**CITY OF WINTER GARDEN
DEVELOPMENT REVIEW COMMITTEE
MINUTES
April 9, 2025**

Agenda Item #3: East Crown Point Complex – REZONING

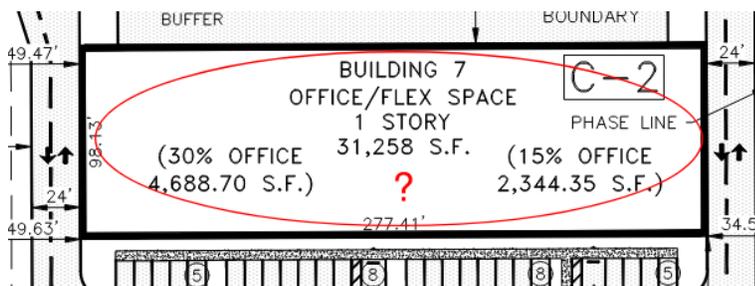
- b. The phase line stops at the cross-access easement/drive aisle. When would this drive be built? During Phase 1A or Phase 1B? This the same for the entire development. Do not bifurcate the phasing in this way.** City staff stated both parking and landscaping of each lot stands alone. Applicant understood.

- c. The building numbers should match the phasing. Building 1 is in Phase 3A and Building 8 & 9 are in the first Phase.** City staff asked that applicants clearly label and ensure the phasing is legible. Applicants understood.
- e. Building 7 is a single building but is showing different "office" square footages for the same building. Even after adding up the square footages the percentages do not work out.** City staff stated more information is needed on the breakdown of the office space. Applicants understood.
